UNITED STATES PATENT AND TRADEMARK OFFICE

APPLICATION NO.	FILING DATE	FIRST NAMED INVENTOR	ATTORNEY DOCKET NO.	CONFIRMATION NO.
10/522,855	07/01/2005	Minoru Yamamoto	122383	5238
25944	7590	05/10/2007		
OLIFF & BERRIDGE, PLC P.O. BOX 19928 ALEXANDRIA, VA 22320			EXAMINER MCCLAIN, GERALD	
			ART UNIT 3653	PAPER NUMBER
			MAIL DATE 05/10/2007	DELIVERY MODE PAPER

Office Action Summary

DETAILED ACTION

FIG. 6

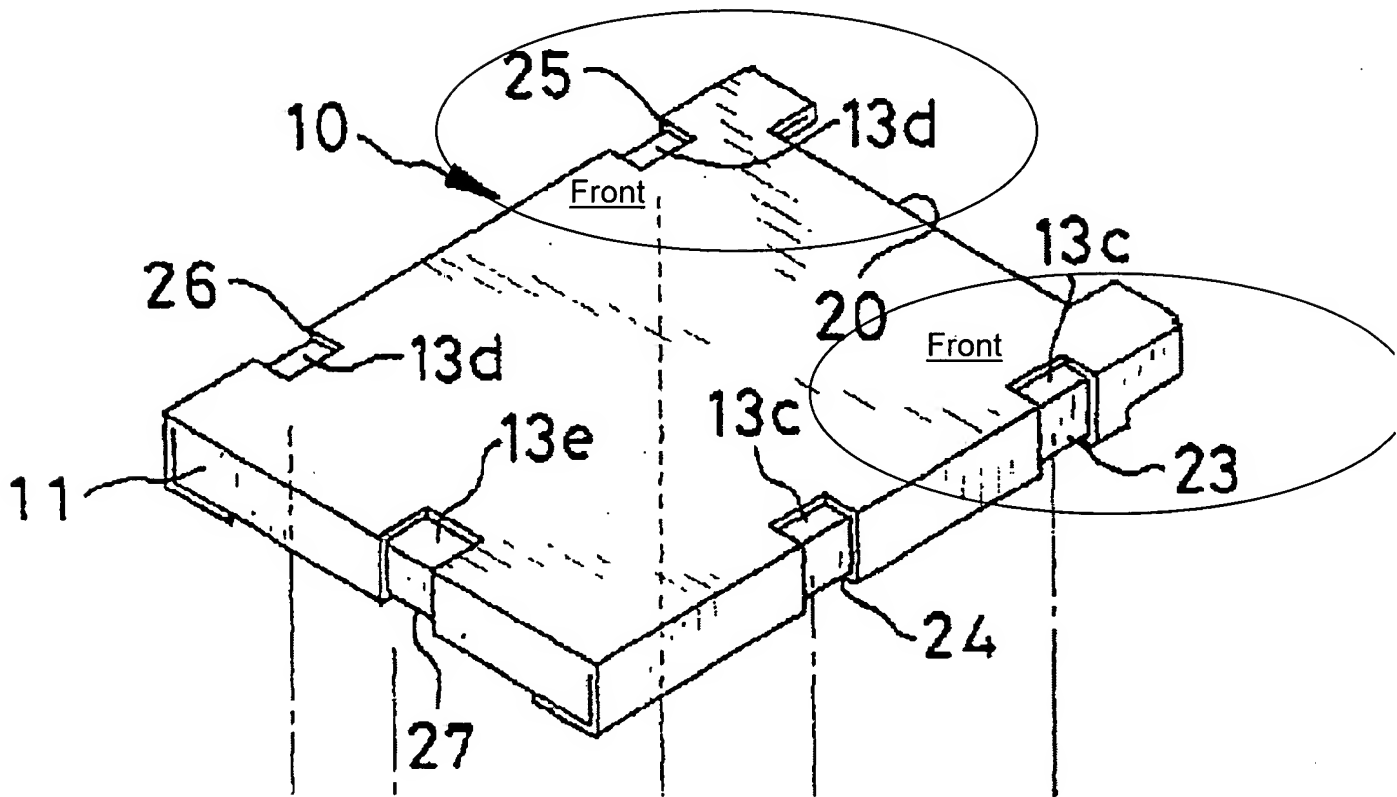
Claims 1 and 16-17: package member (10); sheet package (10); printer (abstract); side part (23 and 25); edge (23 and 25; See FIG. 6 below, note that the front sections are identified in regions.); sheet storage unit (40); projecting part (55);

Claim 9: projecting part (55); level difference (See FIG. 6, 50 and 52); side wall of the sheet storage unit (55 at 40); side part (23 and 25);
